THE MARYLAND-NATIONAL CAPITAL PARK AND PLANNING COMMISSION

REVIEW TYPE: Mandatory Referral

PROJECT NAME: Montgomery Hills Junior High School Reuse

CASE NUMBER: 02107-DPWT-1

SITE PLAN

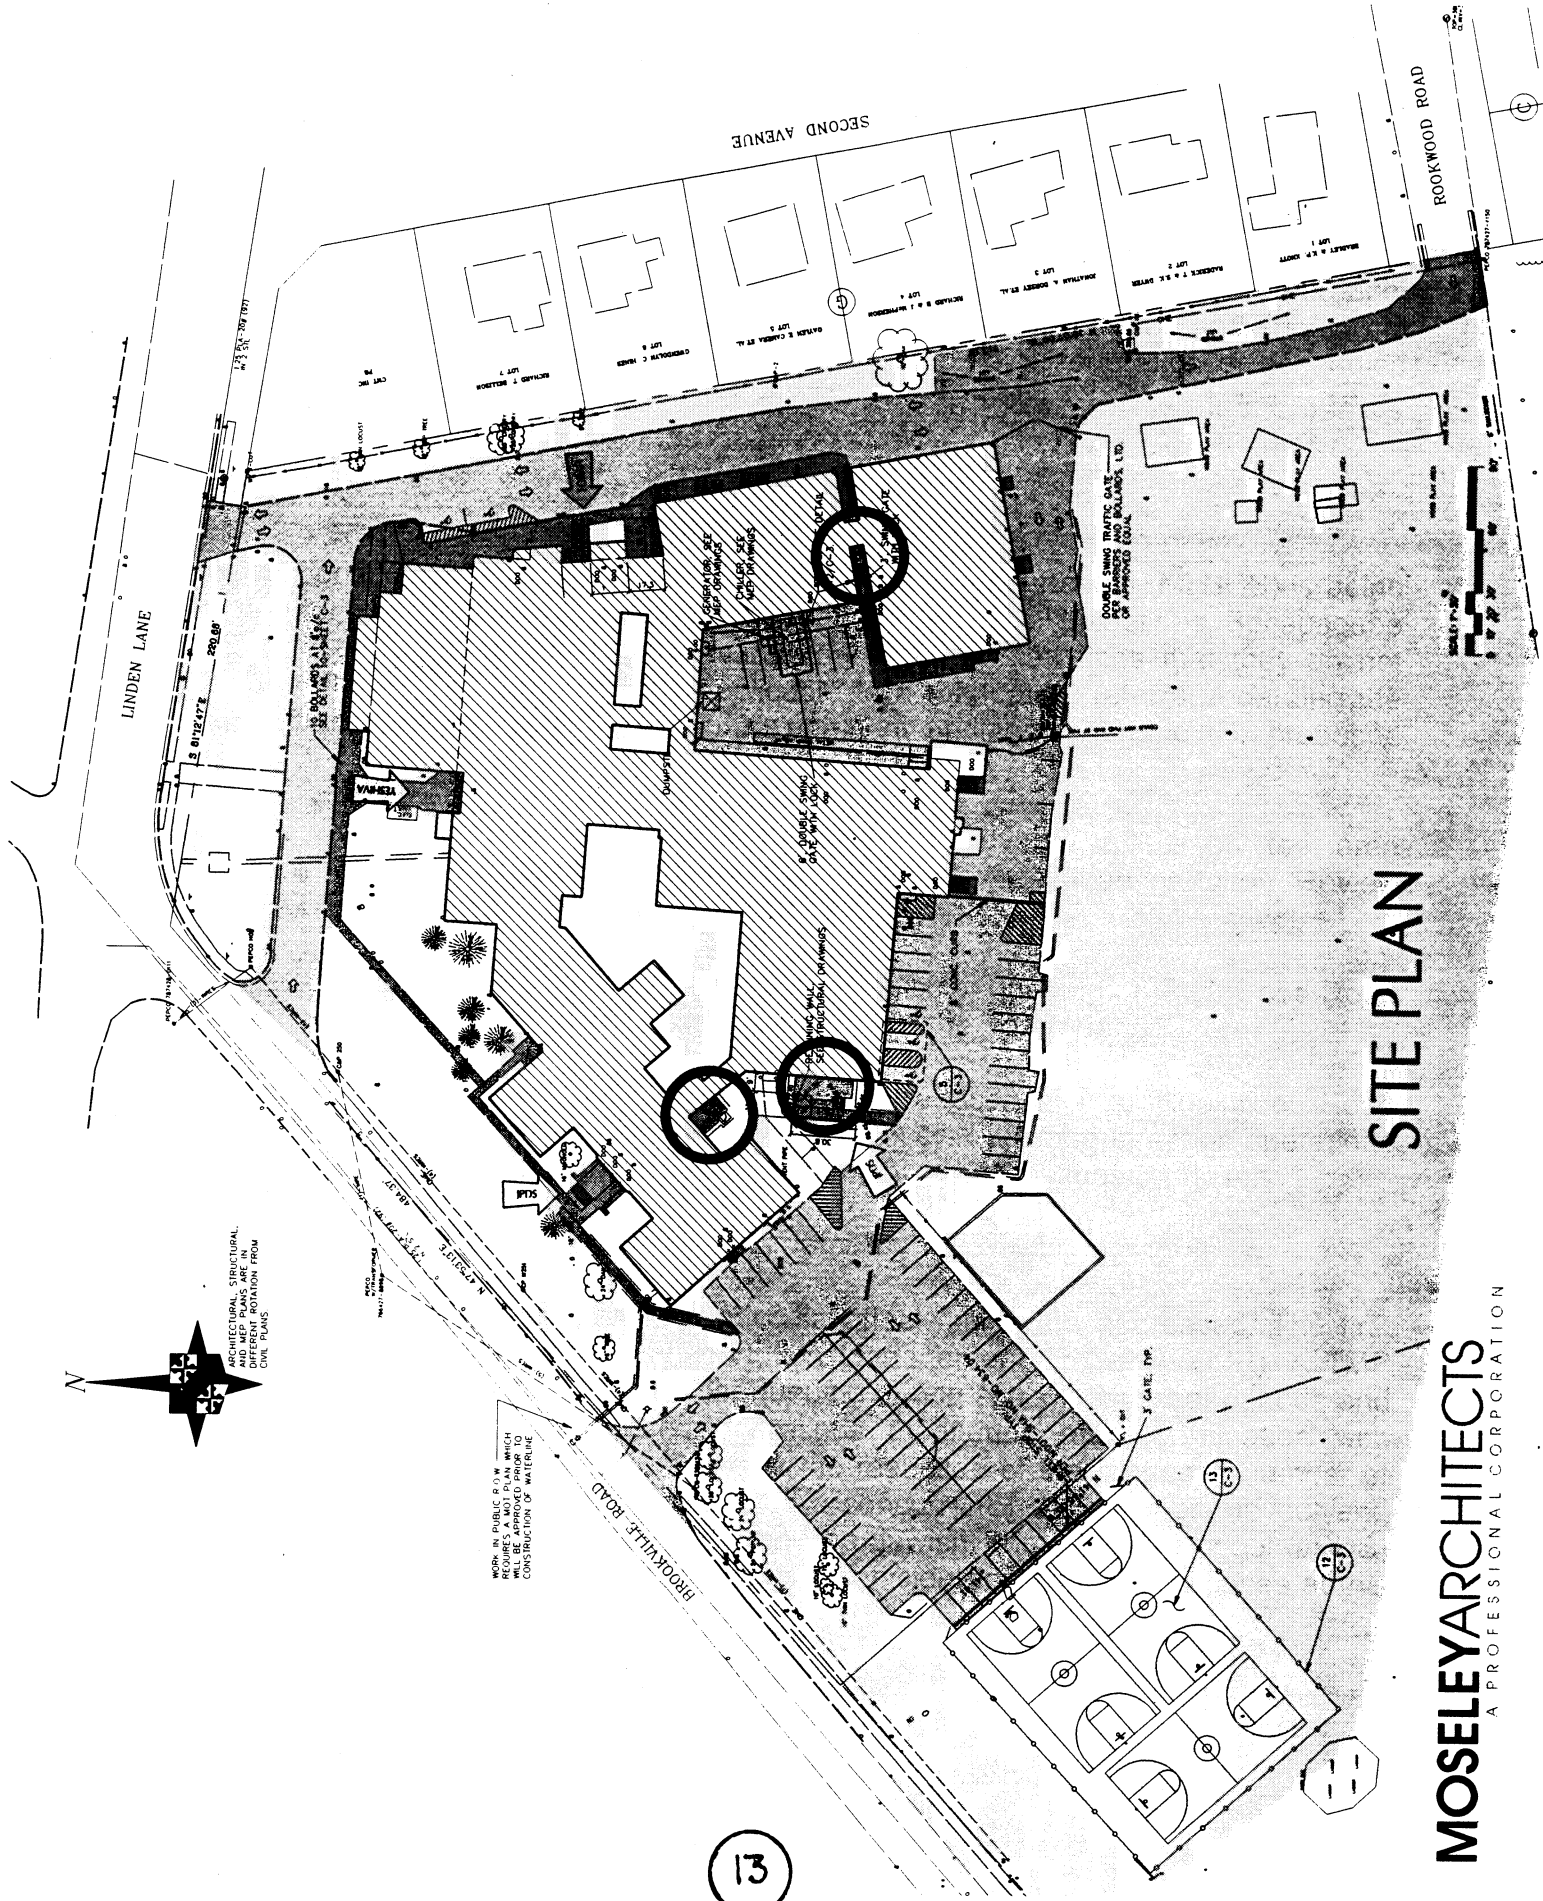
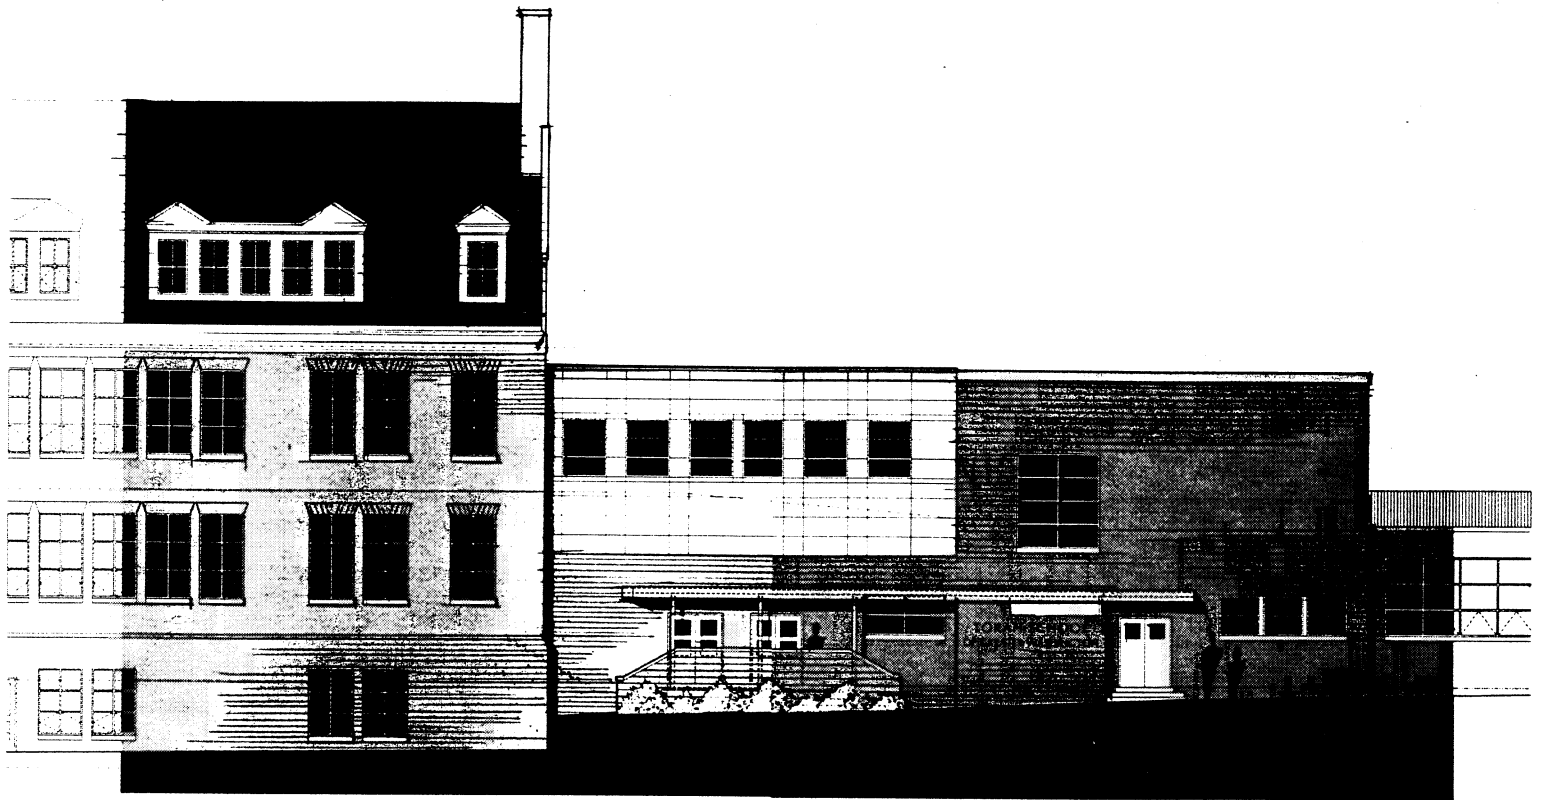
3. The applicant should provide a sidewalk along the Brookville Road parking lot entrance connecting the existing sidewalk along Brookville Road to the proposed sidewalk along the west side of the building.

The subject application shows separate student entrances for each school – indicated by arrows on the Site Plan (Attachment 3)-- and two vehicular pick-up and drop-off areas. Pick-up and drop-off for JPDS would occur at the parking area and driveway on the southwestern edge of the site with students entering the building via the Brookville Road entrances. Pick-up and drop-off activity for the Yeshiva and Torah Schools would occur on the alleyway along the east side of the campus, with the Yeshiva students walking to the front of the building along Linden Lane to enter the facility. Vehicles would enter from Rookwood Road on the rear of the site and exit the site via Linden Lane. (See Attachment 7- Site Circulation.) Pick-up and drop-off activity for the Yeshiva and Torah Schools would be staggered so that both did not occur at the same time. The proposed operations are likely to cause some vehicular queuing on Rookwood Road during the afternoon school dismissal period for the Torah School.

The community has requested that the Rookwood Road entrance to MHJHS be closed, thereby forcing pick-up and drop-offs for the Yeshiva and Torah Schools to access the site via Brookville Road or Linden Lane. Transportation Planning staff note (in Attachment 8) that closing the Rookwood Road entrance would reduce traffic on Rookwood Road and Second Avenue but would also have an overall adverse effect on operations and safety, as long as all three schools remain in the proposed locations.

In addition to maintaining community access to the play fields, the applicant should provide a sidewalk connection from Brookville Road to the fields to facilitate safe pedestrian access.

LANDSCAPING PLAN

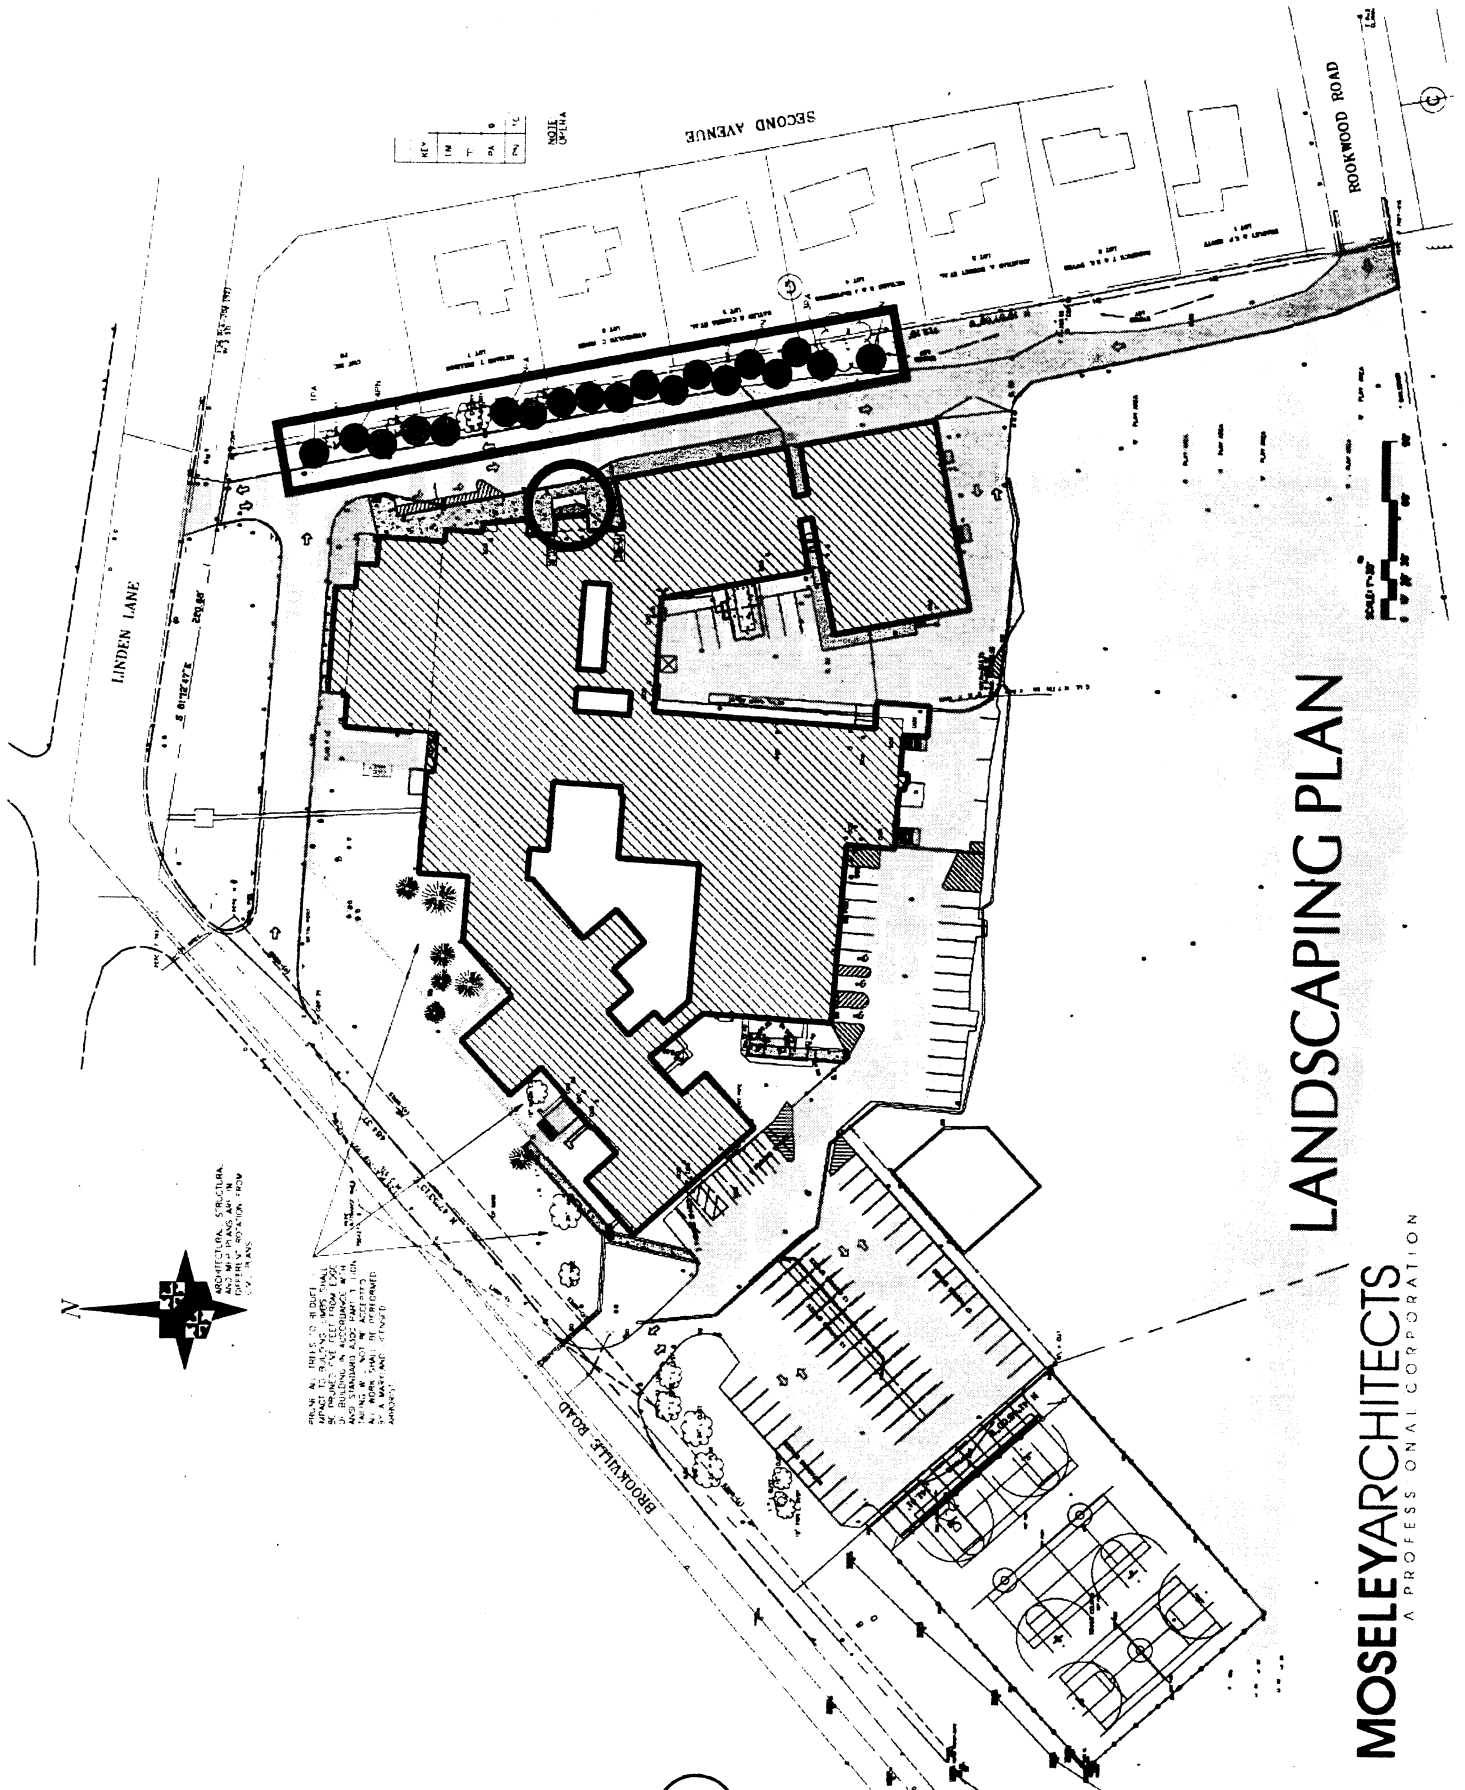
4. The surface parking lot should be landscaped with shade trees as required by the Zoning Ordinance.
5. The applicant should submit for Planning Board approval a Transportation Management Plan that accomplishes the following:

As indicated in the table below, the MHJHS site is consistent with the standards for the R-60 zone with the exceptions of a) the maximum building height, and b) the minimum parking lot setback. However, the Mandatory Referral proposal reflects the existing building height and parking lot setback; no changes are proposed from the situation which has existed since MHJHS was utilized as a public school. *Although the parking lot satisfies the interior green space requirement in the Zoning Ordinance, these green areas should be planted with shade trees as required by Section 59-E-2.73 of the Ordinance.*

The applicant for the subject case has been responsive in terms of addressing the staff’s initial concerns about landscaping and lighting. For example, the applicant has replaced proposed floodlights that could have negatively impacted adjoining properties. The staff continues to be concerned about an existing gravel parking lot along the driveway from Rookwood Road that abuts the rear of several single family homes along Second Avenue. *This gravel parking lot should be replaced by a landscaped area to buffer these homes from the existing driveway. The landscaped area shown on Attachment 6 (Landscaping Plan) as a long rectangle should be extended all the way to Rookwood Road.*
